Subject: Permit modification request for the proposed improvements to US 17 in Onslow, Jones and Craven Counties, TIP No. R-2514B, C & D. Debit \$570 and \$100 from WBS 34442.1.3.

Reference: CWA Section 404 permit Action ID SAW-2008-00528 issued May 22, 2015  
401 Water Quality Certification No. 004012 issued March 2, 2015  
NCDWR Project No. 20141169v1  
N.C. Coastal Area Management Act Permit 43-15 issued March 24, 2015

# SITE 6

PERMIT DRAWING  
SHEET 15 OF 62

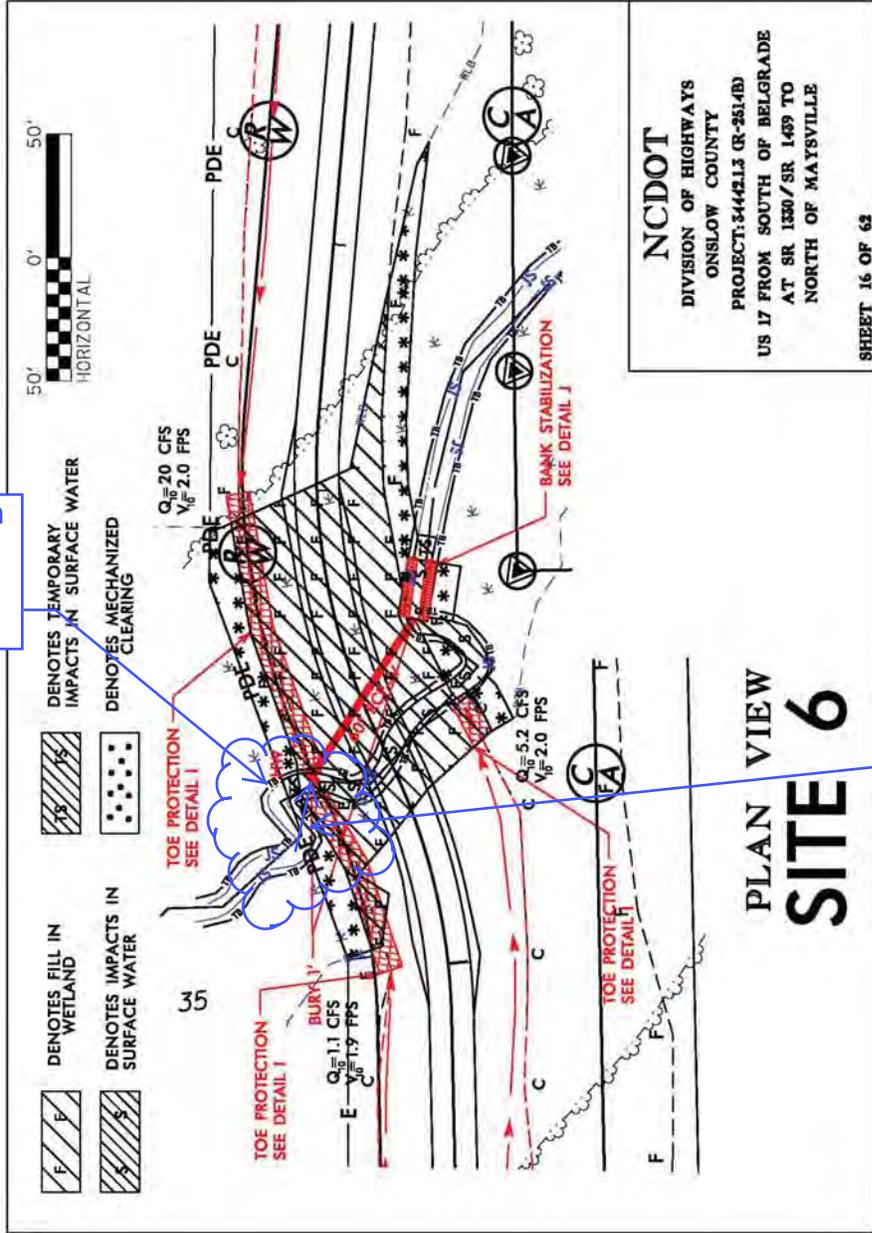
As you are aware, the North Carolina Department of Transportation (NCDOT) is constructing improvements to US 17 from SR 1330/SR 1439 south of Belgrade to the New Bern Bypass. Permits for this project were issued last year, and the project was let to construction on June 16, 2015. The NCDOT is requesting a permit modification to allow for changes the contractor wants to make at Site 6, where erosion is occurring around the edge of the planned 60" culvert pipe at the inlet headwall.

During a recent walkthrough with environmental agencies, the fix that was discussed in the field was to excavate a new channel, fill in the old channel, and plate the slopes with rip rap. The total impact is approximately 15 linear feet of new channel, and approximately 25 linear feet of filling and plating in the old stream channel. Detailed drawings of this proposed work are attached.

Modification Location

Fill in Stream "S-turn" and Plate Slope with Rip Rap

Relocate channel by removing the sharp turn (See picture Attached)

Place Excavated  
(Local Material  
back into Stream  
"S-Turn" then place  
Rip Rap Rock  
Plating along new  
Stream Bank

Excavate material  
and Shape New  
Channel

New Channel  
Location
